# PRODUCT BULLETIN

**Date:** May 06, 2019  
**Update Number:** P2019-13  
**Subject:** CAPXL Updated Firmware Release v1.27  
**Product Affected:** CAPXL

## **Type of Change: 1.27 firmware release for CAPXL**

Figure 1: update firmware button screen shot from Controllers screen

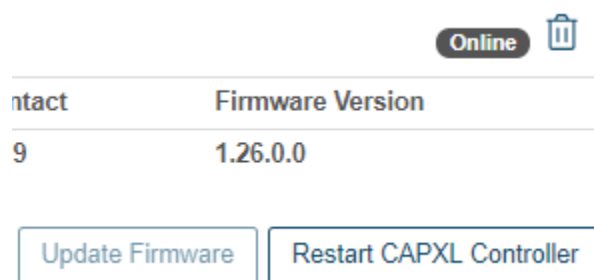
1. Login to MyQBusiness.com and navigate to the facility with the CAPXL to be upgraded.
2. On the facilities tab, open Controllers and select the CAPXL to be upgraded.
3. Confirm the CAPXL is online and confirm the "Update Firmware" button is available

4. Click the "Update Firmware" button.
  - a. **Press the button only once.** Repressing the upgrade button may restart the process resulting in longer upgrade times
  - b. A confirmation message will appear and the CAPXL will immediately begin downloading the new firmware and will automatically perform a restart. After the restart, the CAPXL will maintain its previous settings and resident database. After the restart is complete, it will show as Online and the Update Firmware button will no longer be active.
